**The Arcade, Dewsbury
& 18-20 Corporation Street / 17 Foundry Street**

Design and Heritage Statement Addendum

1705-BDP-AD-XX-RG-Z-00006

SCALE
@ A1
1 : 100

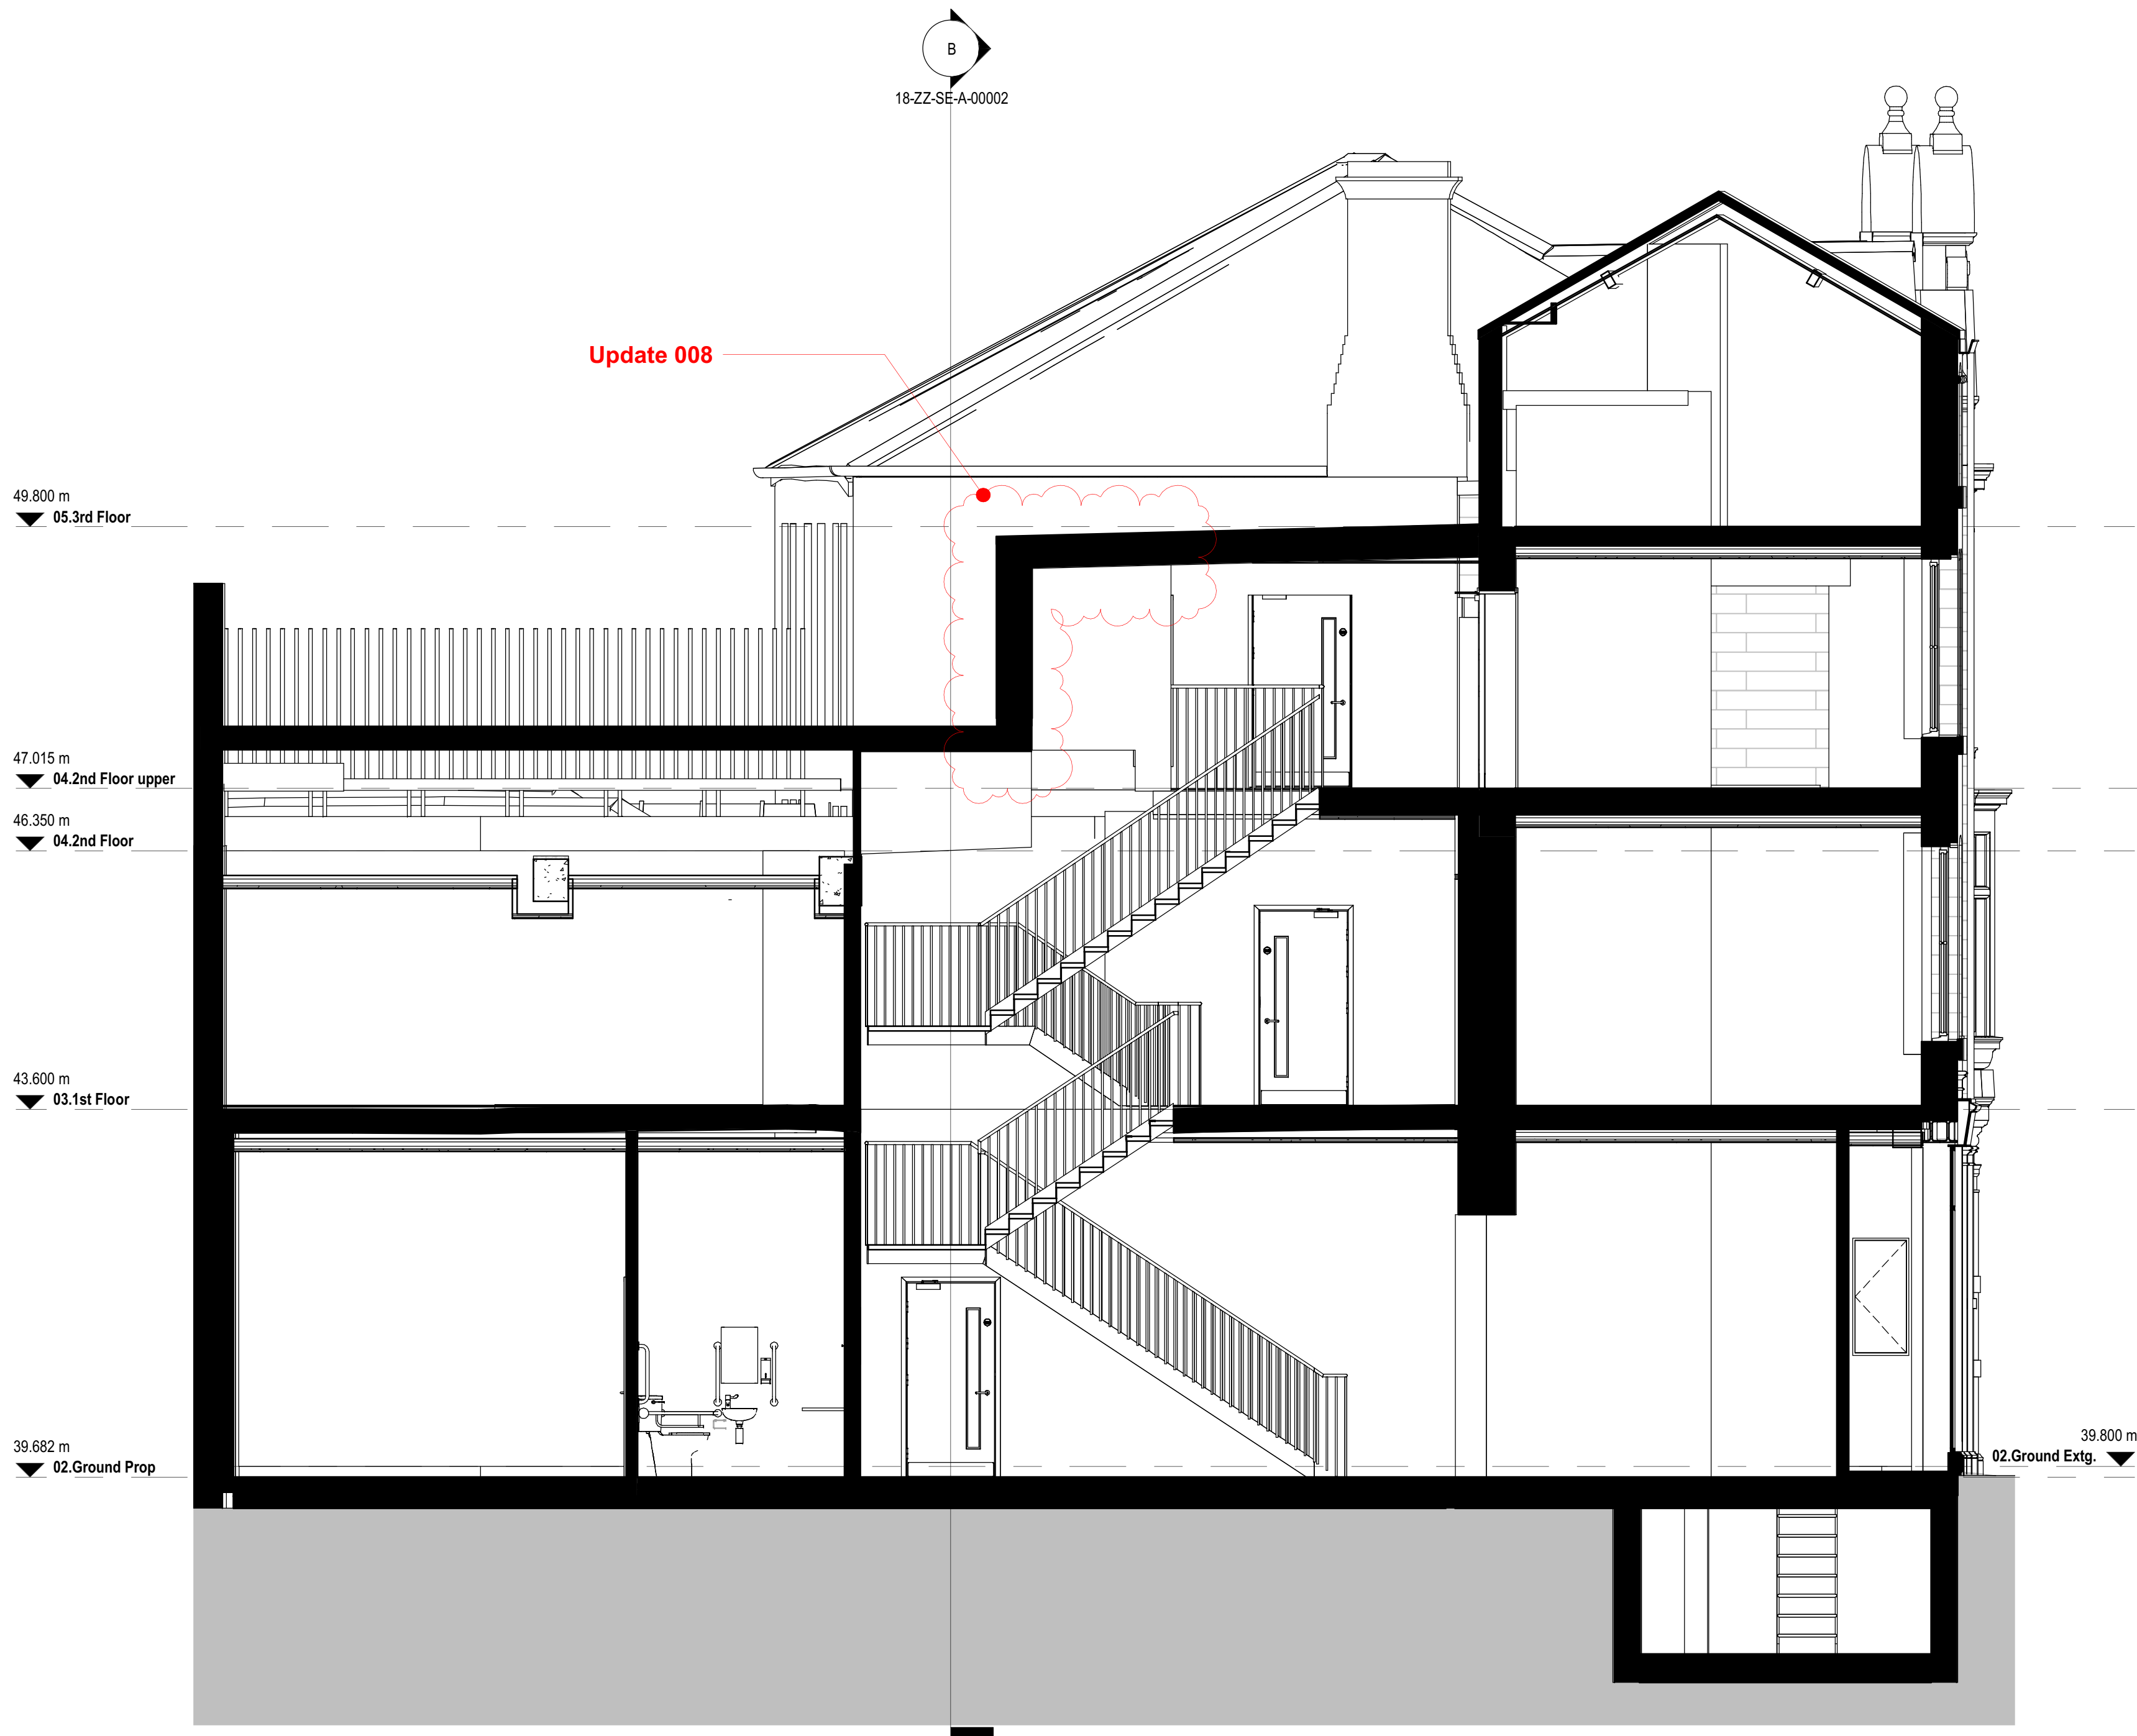
022	Central Arcade, 14-16 Corporation Street and 18-20 Corporation Street Refer to elevation drawings	Windows	Repair windows where possible using traditional techniques. Some windows were known to have extensive wet or dry rot, or were absent and were therefore proposed to be replaced.	Additional windows were found to have extensive wet and dry rot. (2 to 14 Corporation Street North Elevation, 2 to Central Arcade East Elevation, and 2 to Central Arcade West Elevation, 3 to 18-20 Corporation Street North Elevation)	CONDITION: These additional windows are so extensively decayed to the extent that they are in very bad condition and unsuitable for repair.	Replace 6 no. windows, in addition to the 3 no. already proposed to be replaced (in unit 30, shown on Section AA). Replacement windows to match existing in size, proportions and timber profiles.	Negligible	1705-BDP-AD-XX-EL-A-20001_P01 1705-BDP-AD-XX-EL-A-20005_T01 1705-BDP-AD-XX-EL-A-20004_P01 1705-BDP-AD-XX-SE-A-20002_P01 1705-BDP-18-ZZ-EL-A-00002_P04	1705-BDP-AD-XX-EL-A-20001_T02 1705-BDP-AD-XX-EL-A-20003_T02 1705-BDP-AD-XX-EL-A-20004_T02 1705-BDP-AD-XX-SE-A-20002_T02 1705-BDP-18-ZZ-EL-A-00002_P05

DRAWING TITLE
Sections as Proposed

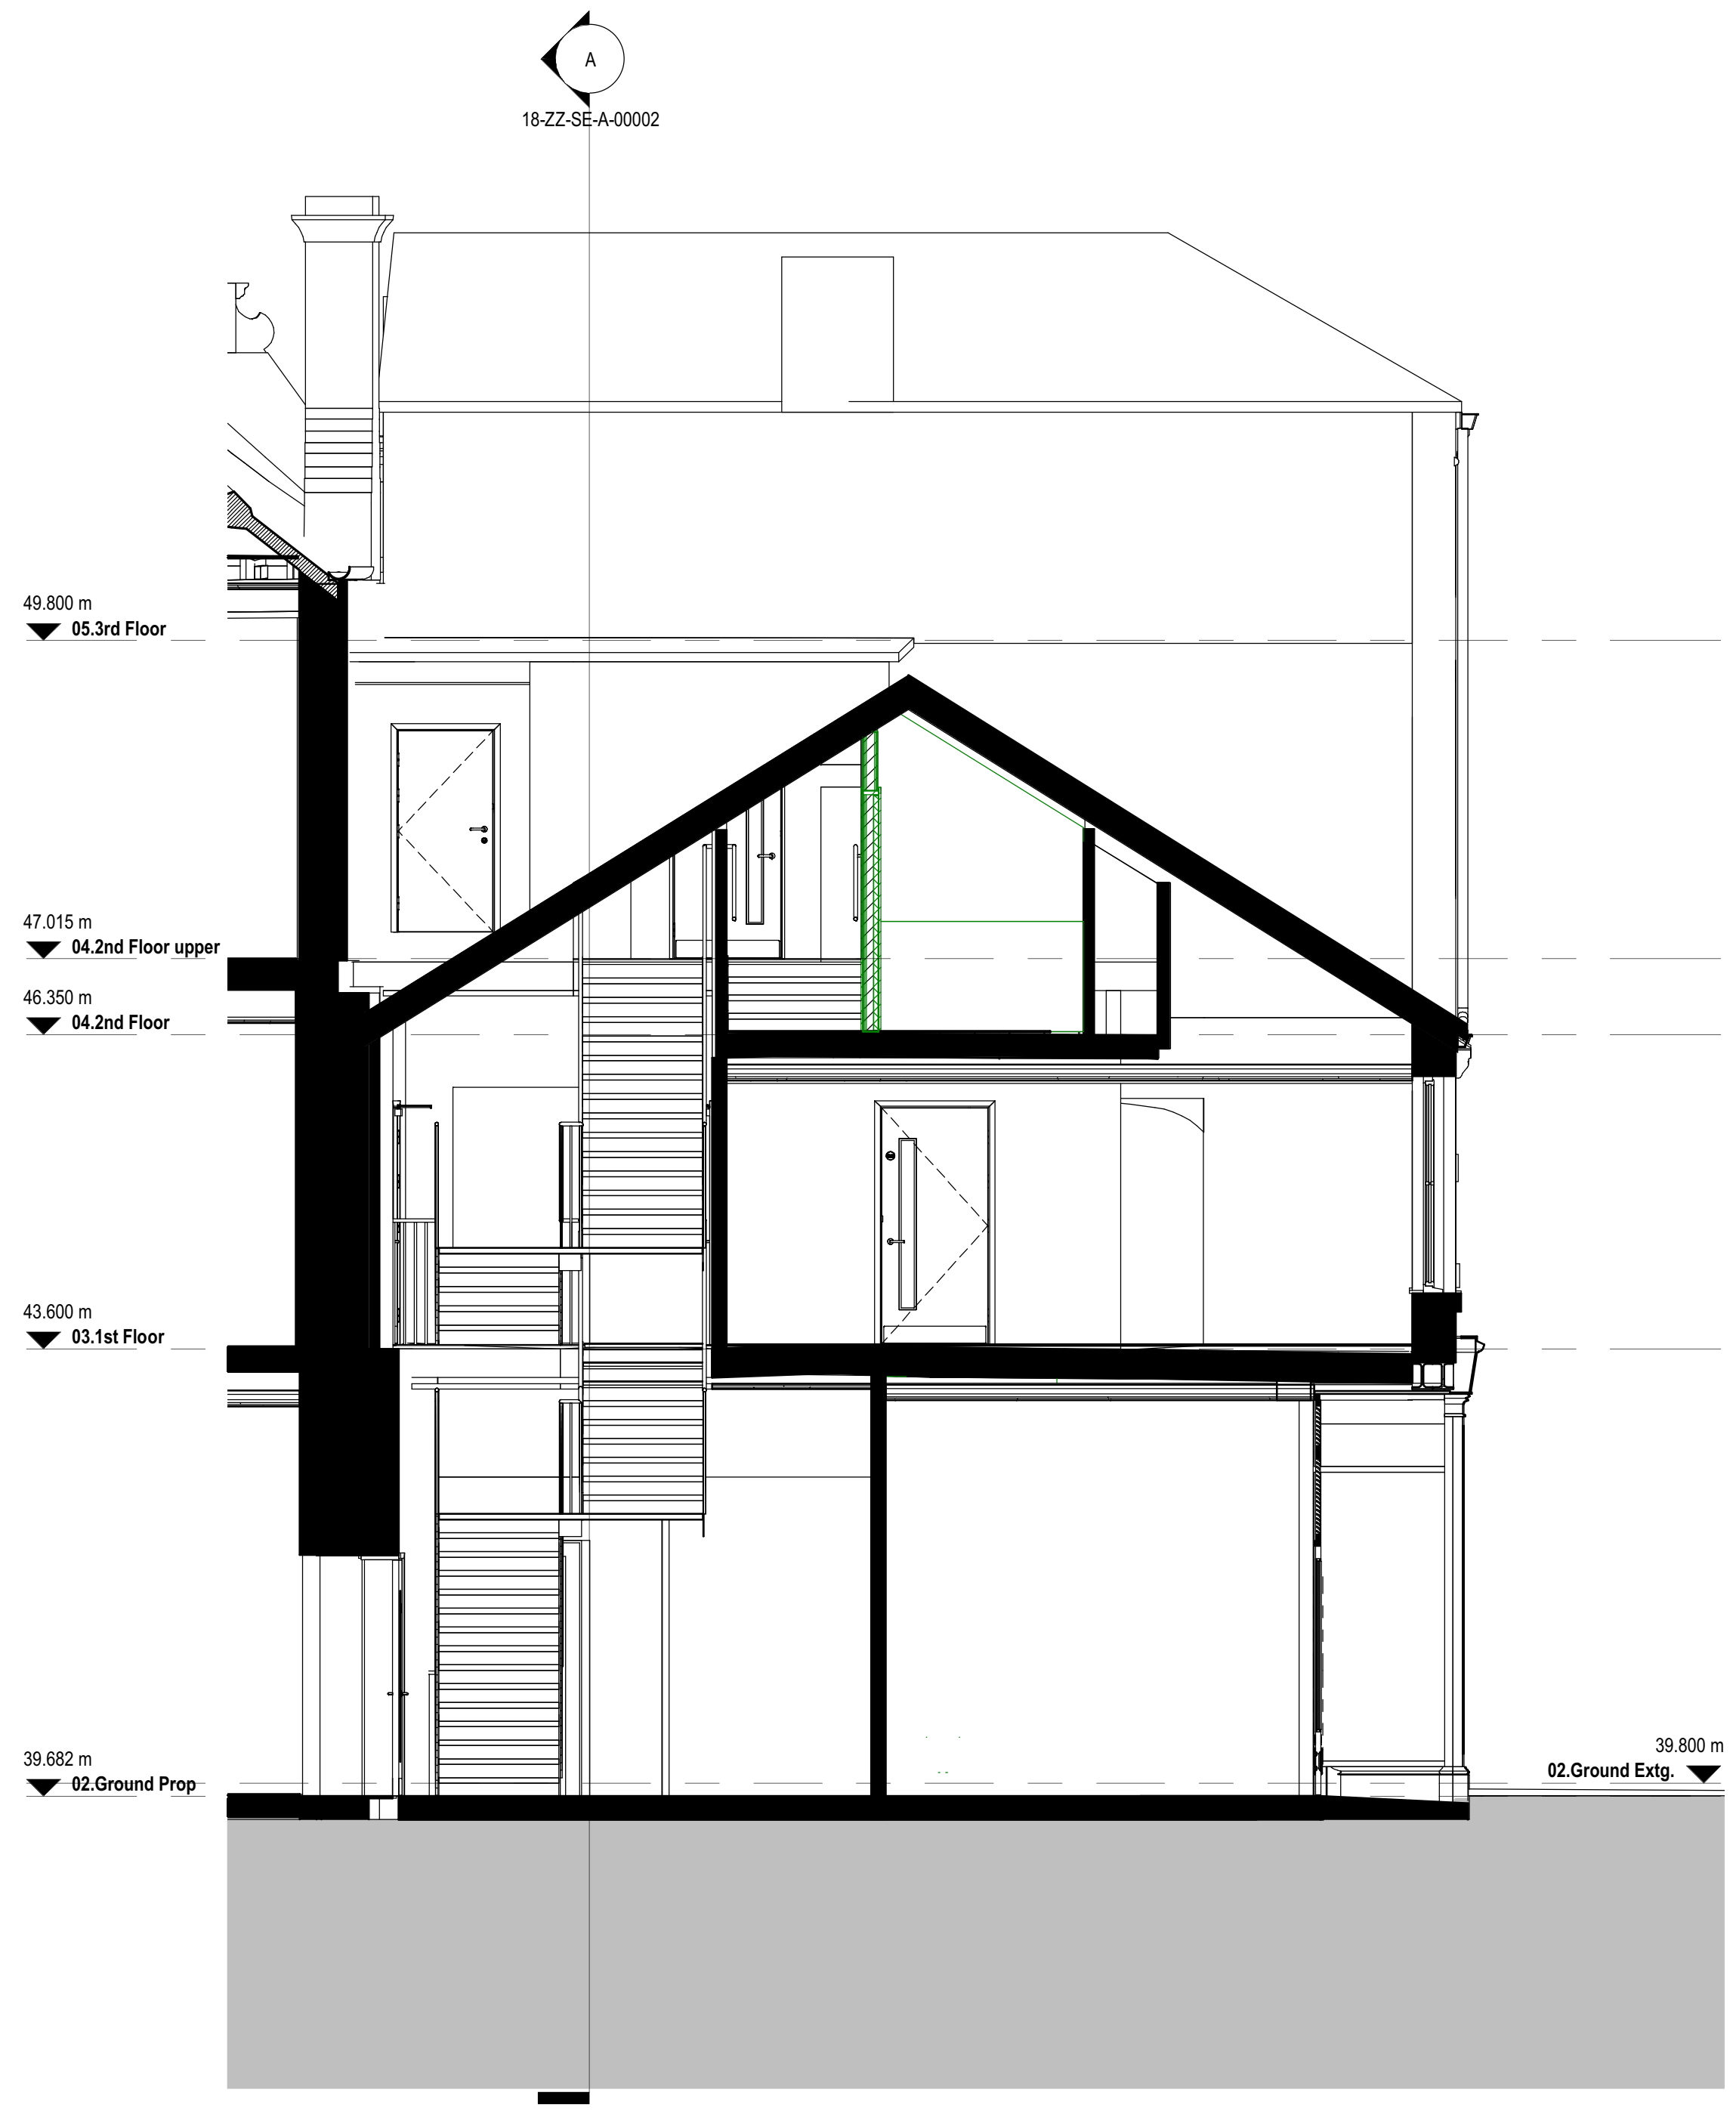
008	17 Foundry Street	Roof	Replace an area of the existing pitched roof (facing away from the principal elevation) with an area of flat roof to provide increased headroom for a new staircase.	The profile of the existing pitched roof and the timber purlins beneath the common rafter extend further into the proposed stair area than previously known.	PERFORMANCE: The extent of the previously proposed roof would not provide sufficient headroom at the head of the new stair for building regulations compliance.	Slightly increase the extent of this area of flat roof. Note that this will still remain entirely at the rear of the building so will not affect the roof slope on the principal elevation to Foundry Street.	Negligible	1705-BDP-AD-02-PL-A-20001_T01 1705-BDP-AD-03-PL-A-20001_T01 1705-BDP-18-ZZ-PL-A-00002_P06 1705-BDP-18-ZZ-SE-A-00002_P02 1705-BDP-18-SL-PL-A-00003_P02	1705-BDP-AD-02-PL-A-20001_T02 1705-BDP-AD-03-PL-A-20001_T02 1705-BDP-18-ZZ-PL-A-00002_P07 1705-BDP-18-ZZ-SE-A-00002_P03 1705-BDP-18-SL-PL-A-00003_P03
